Commonwealth Edison
One First National Plaza, Chicago, Illinois
Address Reply to: Post Office Box 767
Chicago, Illinois 60690

Subject: Byron Station Units 1 and 2
Braidwood Station Units 1 and 2
Residual Heat Removal System
NRC Docket Nos. 50-454, 50-455,
50-456, and 50-457

ATTACHMENT A

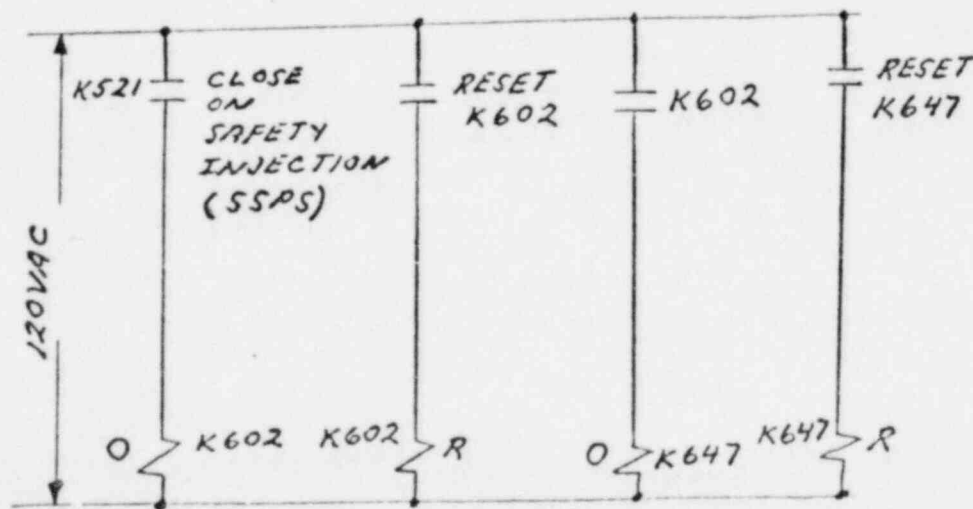
During safety injection when the water level in the RWST reaches a preset trip point, there is an automatic switchover from injection mode to recirculation mode. Manual resetting of the safety injection signal will disable the automatic switchover. The NRC's concern was that the operator would not be aware that the automatic switchover was disabled since no indication of the reset was provided. The safety injection reset circuit will be revised to include an indicating light that will be "turned on" when a safety injection signal is present and "turned off" when the signal is reset. The indicating light will also have a push-to-test feature that will allow the operator to verify that it has not burned out. A typical schematic of the indicating light circuit is provided below:

The K647 Relay is the Output Latch Relay for the Safety Injection Latch Relay K602 as shown in the following sketch:
